July 25, 2014

RE: Draft Bay Delta Conservation Plan and Associated Draft Environmental Impact Report/Environmental Impact Statement (BDCP EIR/EIS)

These comments are submitted in relation to the Bay Delta Conservation Plan (“BDCP” or the “Project”) and associated public review draft environmental documents (EIR/EIS) on behalf of the Friends of Stone Lakes National Wildlife Refuge (“FSL,” formerly known as the Stone Lakes National Wildlife Refuge Association). FSL is a volunteer, nonprofit organization dedicated to the conservation, protection, enhancement and promotion of the Stone Lakes National Wildlife Refuge (“Stone Lakes NWR” or “Refuge”). The comments are solely those of FSL and are independent of Stone Lakes NWR staff and the U.S. Fish and Wildlife Service (“USFWS”).

EXHIBIT I

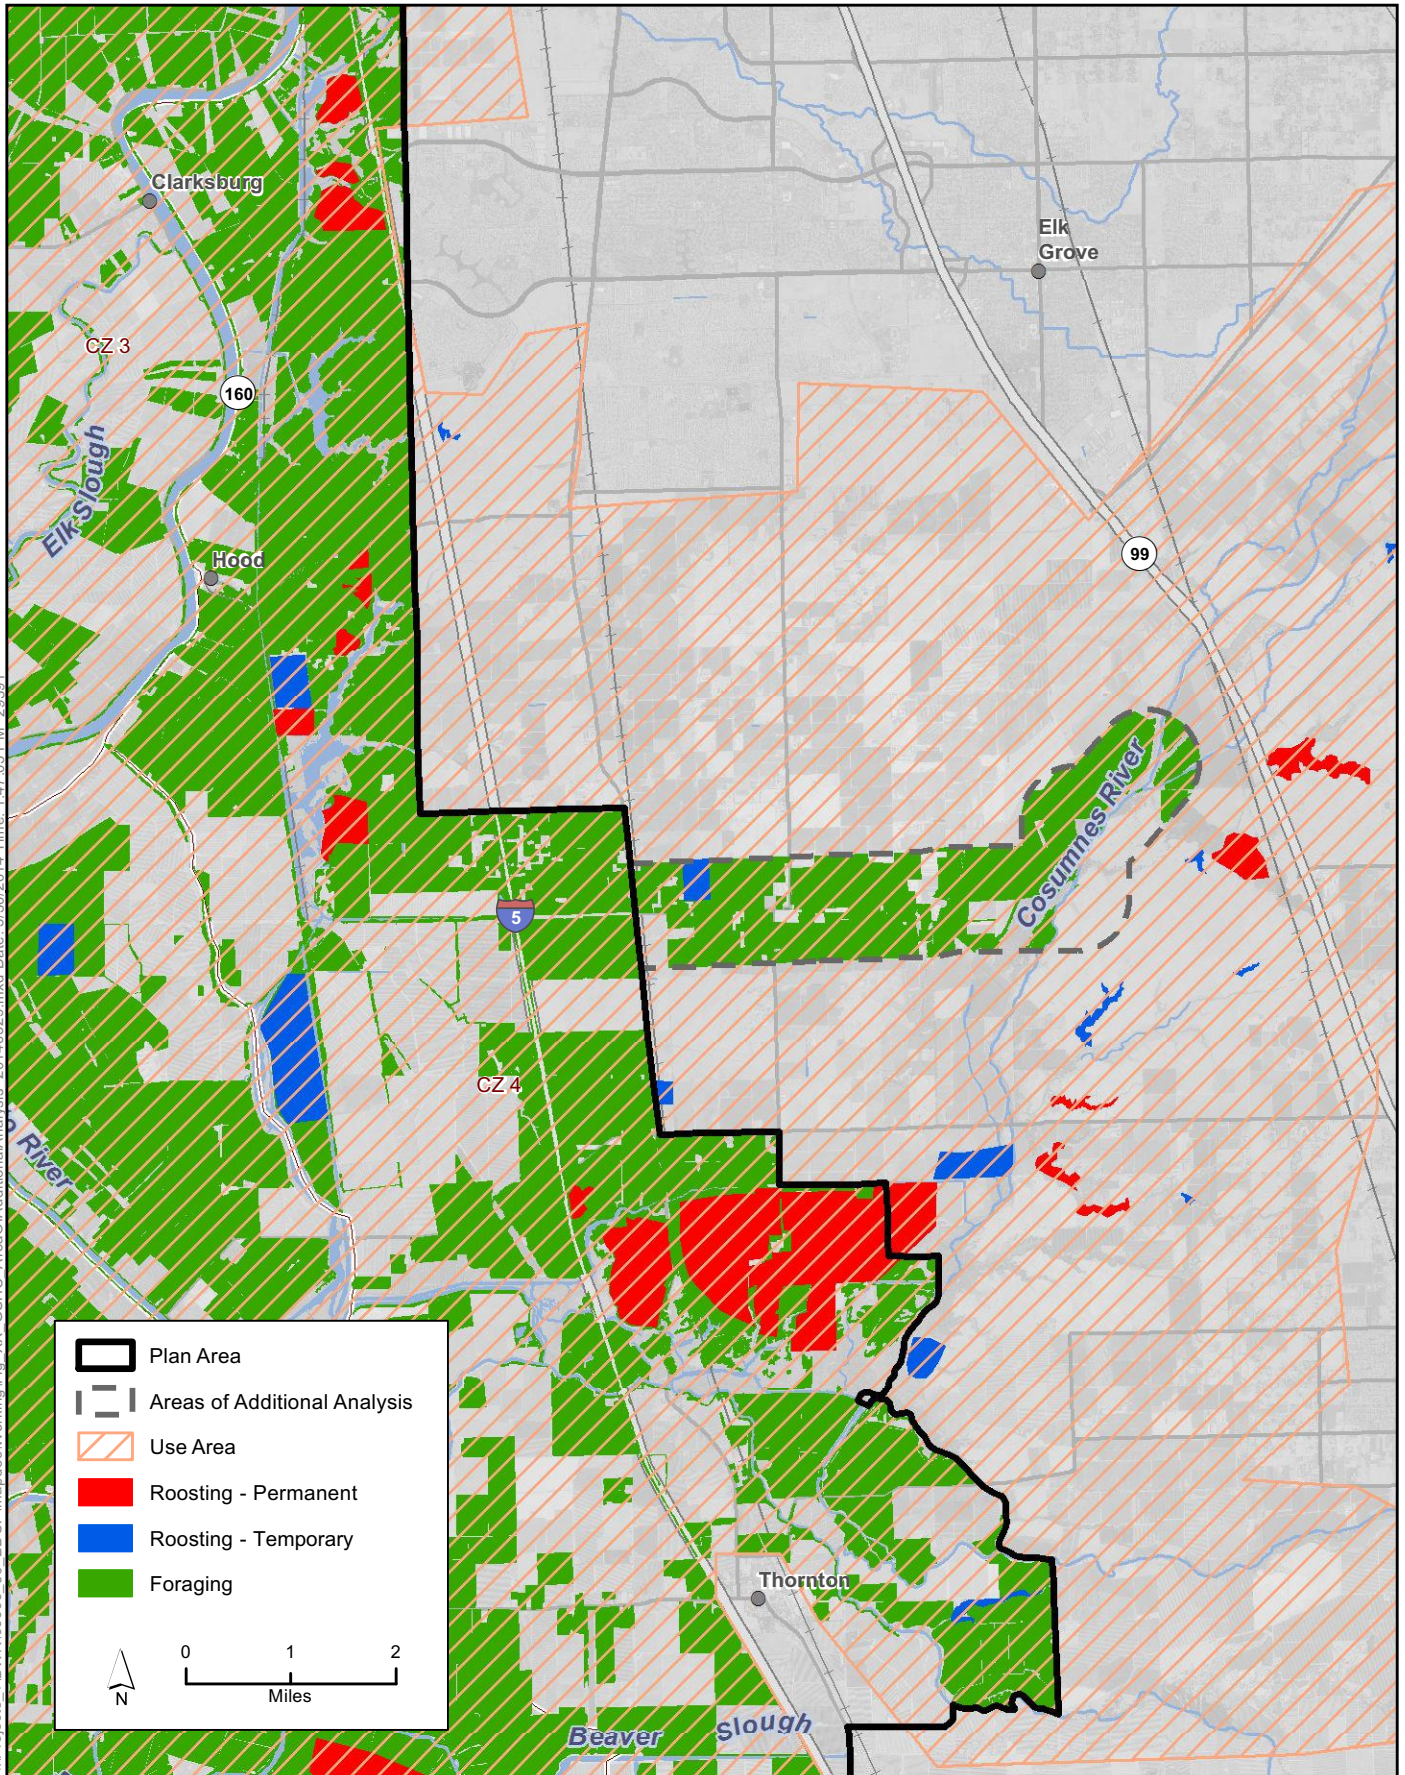
⁷ While Table 1 refers to the transmission lines as within the Plan Area, (BDCP, Appendix 5.J.C, page 4), part of the permanent transmission lines would be in what is referred to as an "area of additional study" (see Exhibit I).

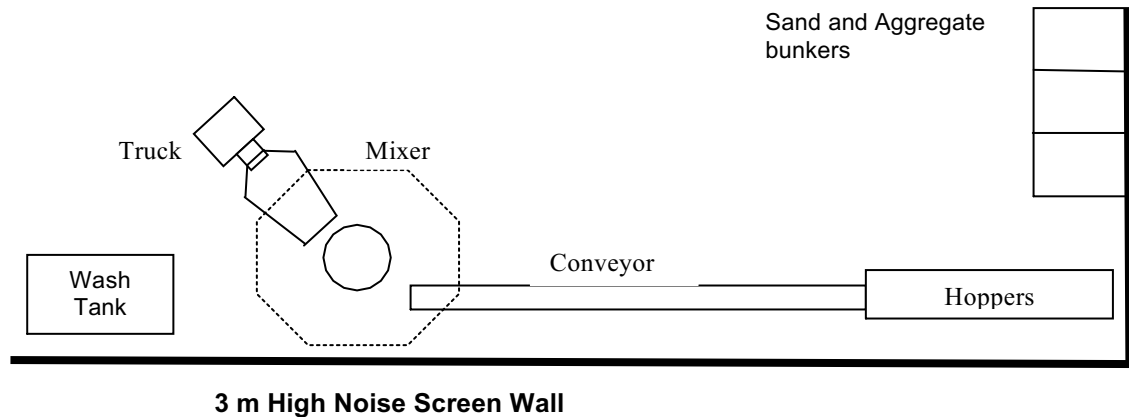
1. The batching plant should be enclosed along its southern and eastern edges by a three metre high noise screen. It should be designed to screen the aggregate bunkers, and to minimise noise propagation in the south and east directions.
2. Concrete truck drum speeds must be limited to 9 rpm either through management procedures or by fitting a limiter to the drum speed control.
3. The hoppers should be lined with a resilient surface or constructed from damped steel sheet to reduce impact noise (this should reduce the noise generated at high level by at least 5 dB).
4. The concrete trucks should use the suggested route to avoid movements close to the eastern boundary.

Layout may be different to this example so long as the noise sources are as close as possible to the noise screen
